# Changes for RailTopoModel version 1.2 (as required by railML version 3.1)

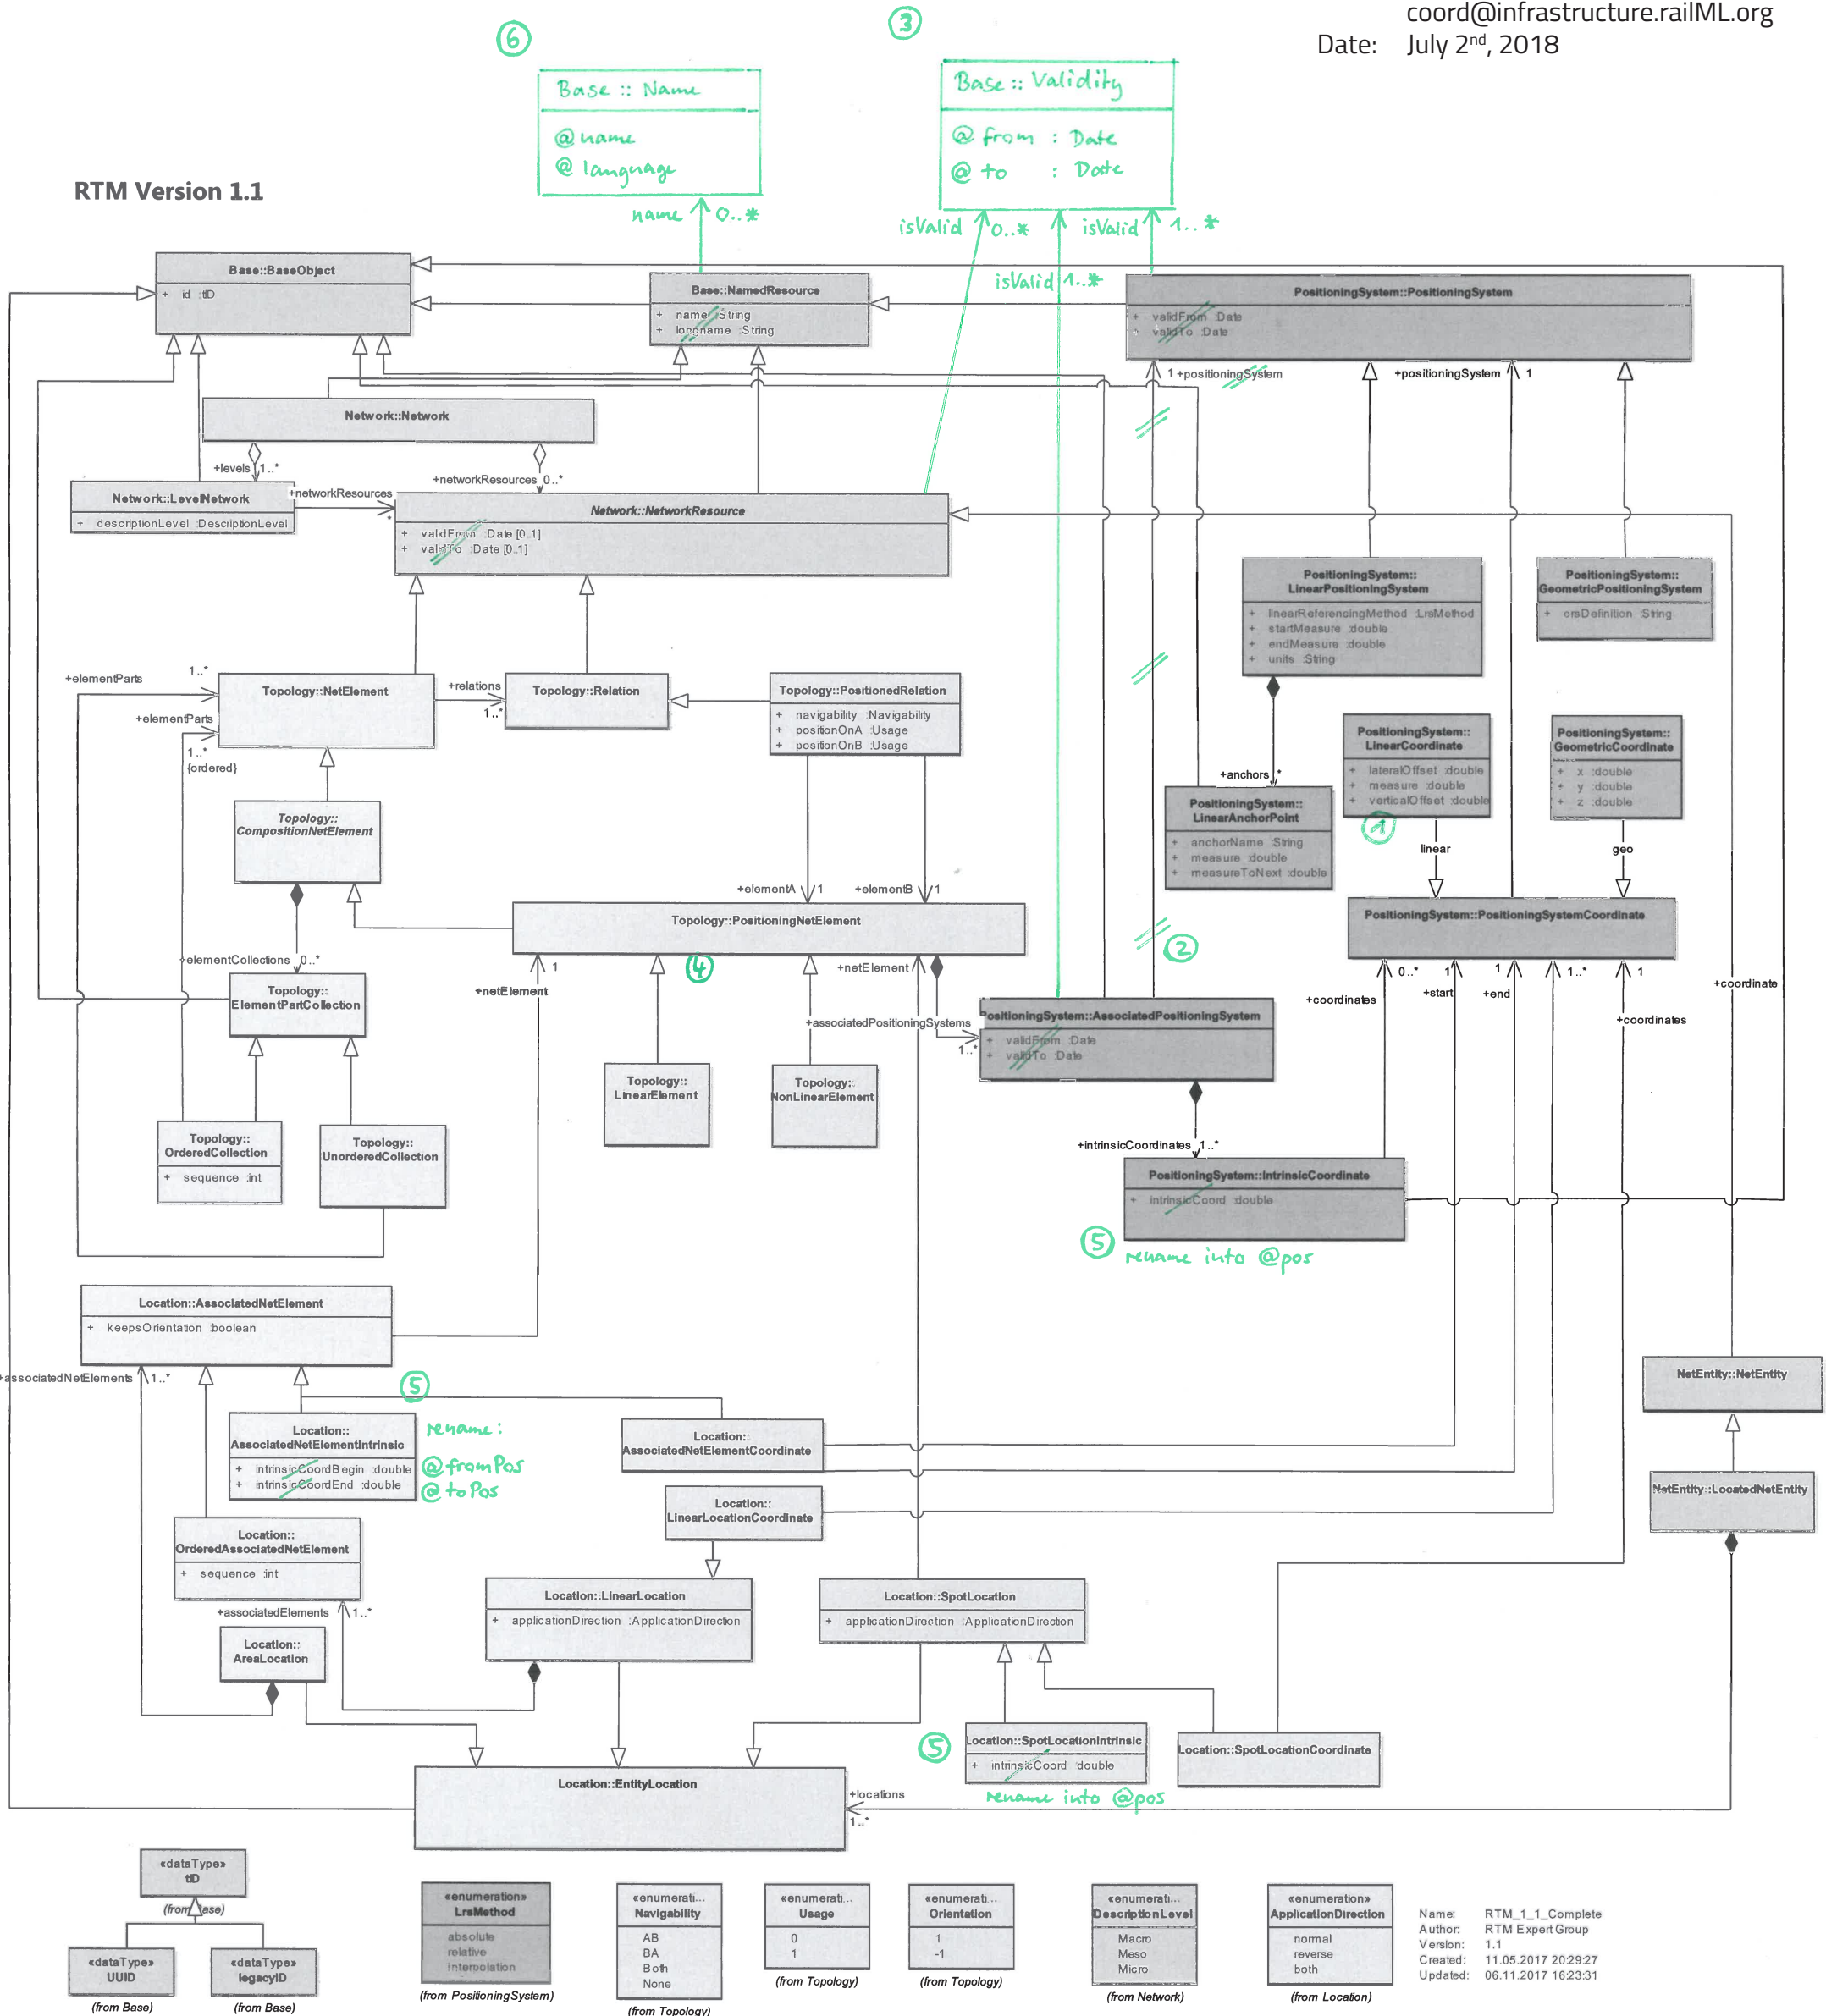
- ① adding new attributes  
 @lateralOffsetSide : left, right  
 @verticalOffsetSide : above, under
- ② removing redundant reference to PositioningSystem
- ③ changing implementation of validity times to allow for multiple validity times
- ④ adding attribute  
 @length : double
- ⑤ renaming of intrinsic coordinates
- ⑥ changing implementation of names to allow for multiple names
